Administrative Action

Preliminary Subdivision

Case File / Name: S-21-11 / Ramblewood Lantern

Nature of Case: A revision and addition to a previously approved cluster unit development that will now contain a total of 500 residential dwelling units comprised of a total of 18 single family lots, 49 townhouse lots, and 433 multi-family units on a 33.49 acre site zoned R-6 Conditional Use District, R-10 Conditional Use District, R-15 Conditional Use District R-30 Conditional Use District and Conservation Management with Special Highway Overlay District -1. 84 of the multi-family units will be located in four buildings spread over 3 lots. Two of these buildings (#29 & #30) will each contain 24 dwelling units and will share a lot. The other two of these buildings (#22 & #23) will be located on individual lots and each contains 18 dwelling units. The remainder of the multifamily units will be considered as Group Housing and will be located in 14 buildings scattered over two lots. This revision includes the addition of 349 additional dwelling units and 14.25 acres to the previously approved cluster development (S-39-09) in the form of 14 additional multifamily buildings. These multifamil

S-21-11/Ramblewood Lantern – Preliminary Subdivision Plan

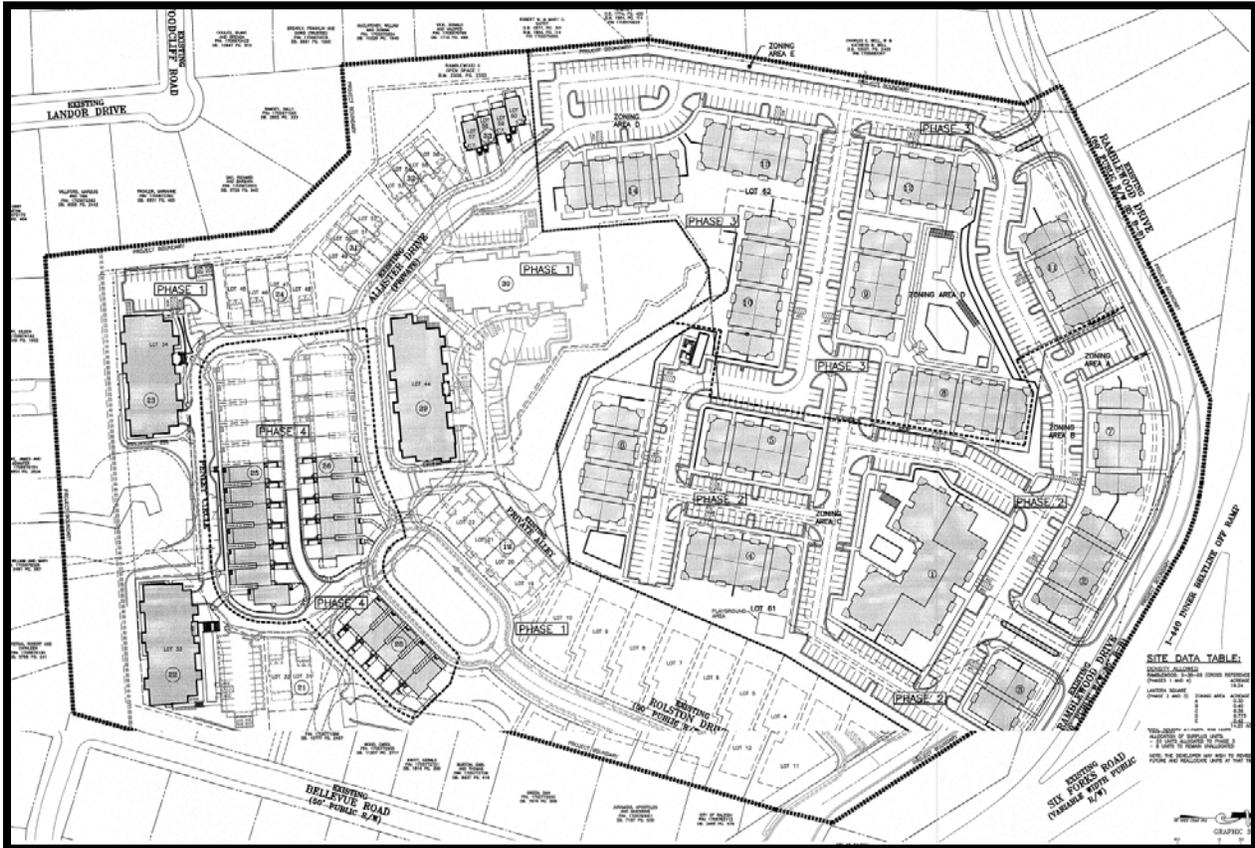
OFFICIAL ACTION: Approval with conditions

- (1) That a stormwater control plan with a stormwater operations and maintenance manual and budget shall be approved by the Stormwater Engineer in compliance with Part 10 Chapter 9, including the designation of buffer areas and open space areas for both projects for stormwater purposes prior to grading or the approval of construction drawings, whichever event comes first;

- (2) That prior to the issuance of a grading permit, the final tree conservation plan must be approved by the Forestry Specialist in the Inspections Department. The plan must show metes and bounds descriptions of all tree conservation areas, and tree protection fence around all tree conservation areas. Tree protection fence must be located in the field and inspected by the Inspections Department. A copy of the approved plan is placed on file in the Planning Department;

- (3) That prior to grading permit issuance, the nitrogen offset payment must be made to a qualifying mitigation bank;

- (4) That prior to issuance of a land disturbing permit for phase 4, private drainage easements are required for all storm drainage and must be recorded prior to as-built certification. This easement must provide access to the BMP's from a public right of way;

- (13) That a recombination map be recorded prior to or in conjunction with the recording of lots, recombining the lots into the lot configuration shown on the preliminary subdivision plan;

- (14) That riparian buffers, in accordance with the preliminary plan and the State of North Carolina regulations, shall be shown on plats for recording along with a note stating "The areas shown on the recorded plat identified as Neuse River Riparian Buffer shall be maintained in their natural or mitigated condition, No person or entity shall fill, grad, excavate, or perform any other land-disturbing activities; nor cut, remove, or harm any vegetation; nor construct any structures nor add any additional impervious surface, nor allow animal grazing or water or any other agricultural use on such protected areas without written authorization from NC Division of Water Quality in accordance with the Riparian Buffer Protection Rules (15A NCAC 2B.0233 or .0259)."
